June 5, 2000
PY-CEI/NRR-2465L

Perry Nuclear Power Plant
Docket No. 50-440
License Amendment Request Regarding A Modification To The
Reactor Core Isolation Cooling System Initiation Logic

SUMMARY

RCIC to Main and Feedwater Pump Turbine Trip Circuit
(Before The Proposed Modification).

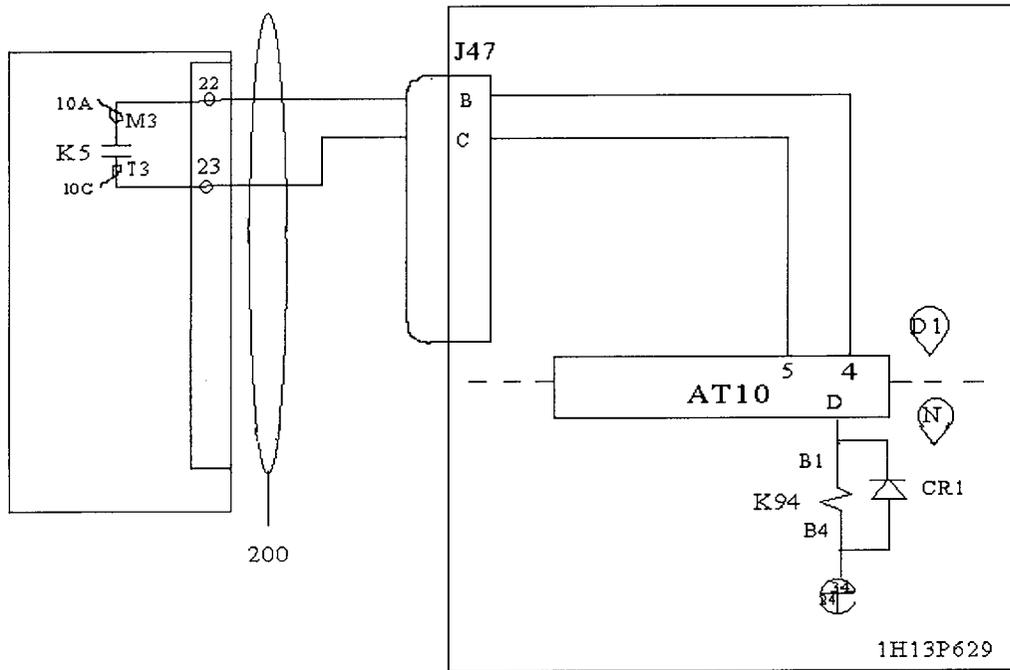
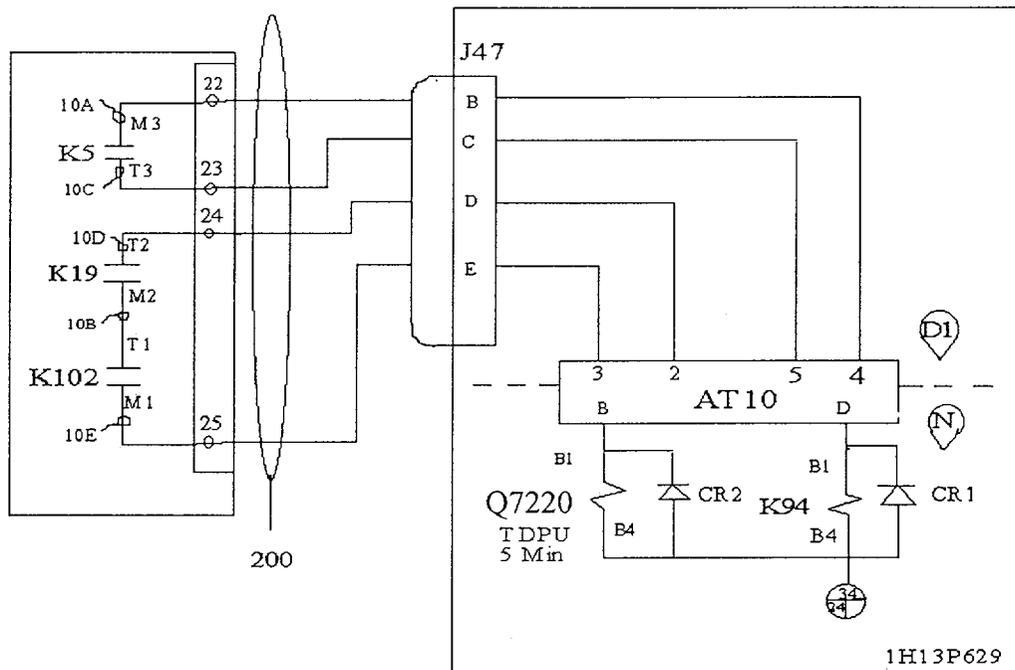
The following describes the existing plant configuration. The existing Feedwater Pump Turbine trip, Main Turbine trip, and associated annunciation circuits are activated by a single non-safety related relay, E51AK94 (K94) (see Figure 1 on Page 9). This relay is a normally de-energized relay with no time delay. When RCIC receives an automatic initiation signal, relay K94 energizes, which trips both the Feedwater Pump Turbines and Main Turbine, and initiates the RCIC system startup annunciator and the Main and Feedwater Pump Turbine trip annunciator.

The following is a short description of the proposed modification. When reactor power is greater than 70%, if the RCIC system initiates operation, the system initiation relay starts a time delay pickup relay, Q7220, for the turbine trip circuits. If this time delay pickup relay times out, signals are sent to trip the turbines. If the operator terminates RCIC system operation by the closure of the RCIC Turbine Trip & Throttle Valve or resetting the RCIC initiation signal before the time delay pickup relay times out, the timing sequence is terminated, thus preventing the trip of the Main and Feedwater Pump Turbines. The proposed modification is accomplished by installing a non-safety related time delay relay (Q7220) in parallel to the existing K94 relay (see Figure 2 on Page 10). This additional time delay relay will allow for up to a 4-½ minute delay for tripping the Feedwater Pump and Main Turbines. Inadvertent RCIC operation is expected to be no more than 5 minutes before corrective action would be taken to trip the RCIC system.

Explanation of logic: When RCIC is automatically initiated relay K5 is energized. Relay contacts K5 M3/T3 close. This energizes relay K94 through optical isolator AT10. Relay K94 contacts are wired to trip both the Main and Feedwater Pump Turbines. Relay K94 also provides the RCIC Initiation annunciator and turbine trip annunciator.

Explanation of logic: When RCIC is automatically initiated relays K5 and K102 are energized. Relay contacts K5 M3/T3 close. This energizes relay K94 through optical isolator AT10. Relay K94 contacts are wired to provide the RCIC initiation annunciator. When relay K102 energizes, relay contacts K102 M1/T1 will close. Note that relay K19 contacts M2/T2 will be closed when the RCIC system is in standby due to valve 1E51F0510 "RCIC Trip Throttle Valve" being open. Once relay K102 is energized relay 1E51Q7220 will start to timeout and will energize after 4-½ minutes. Relay 1E51Q7220 contacts are wired (when energized) to trip the Main and Feedwater Pump Turbines and to provide a turbine trip annunciator. Plant operators will shutdown the RCIC system once it is determined that the RCIC system is not needed (spurious initiation). The RCIC System Operating Instruction (SOI) directs the operator to close valve 1E51F0510 to trip the RCIC turbine. This will de-energize relay K19 and stop the 4-½ minute time delay relay 1E51Q7220 from energizing. An additional control switch (Not shown) will disable the 4-½ minute time delay feature by utilizing relay K94 contacts to trip the Main and Feedwater Pump Turbines when RCIC is initiated. The 4-½ minute time delay will be disabled when reactor power is less than 70%.

Figure 7.7-6 (Sheet 1 of 2)
 [Dwg. B-208-025 (A200)]

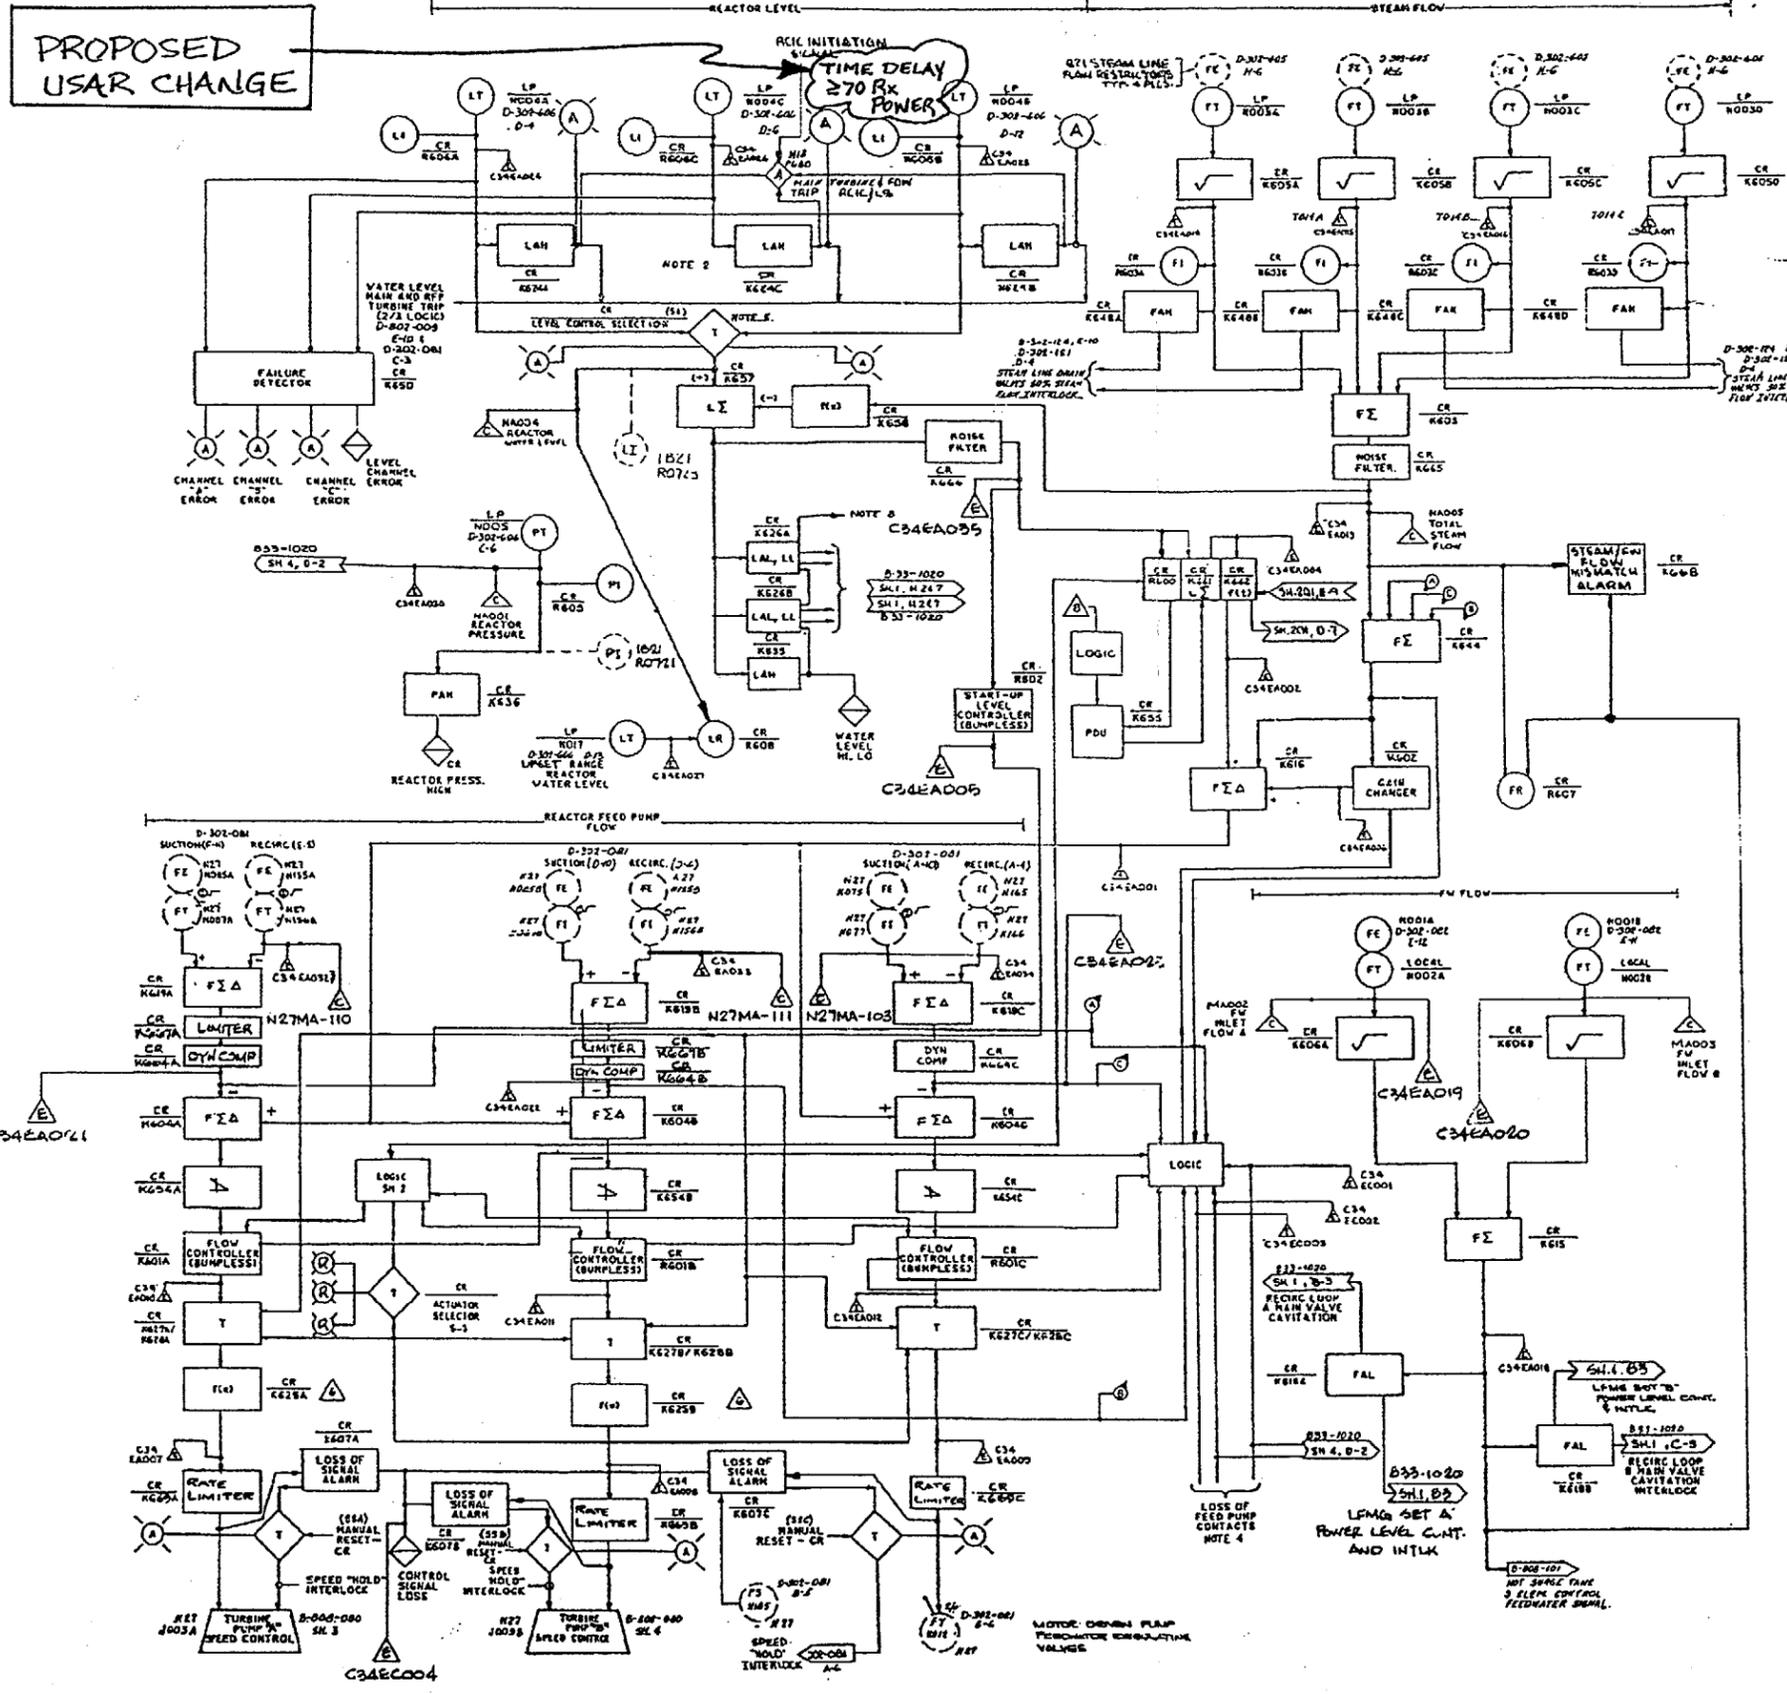
- k. Loss of 24-volt dc electrohydraulic control power supply.
 - l. High level in moisture separators.
 - m. High reactor water level.
 - n. Low shaft pump discharge pressure when turbine is operating at greater than 75 percent of rated speed.
 - o. Operation of the manual mechanical trip at the front standard.
 - p. Low bearing oil pressure to the trip piston.
 - q. RCIC initiation signal time delay \geq 70% Reactor Power.
-
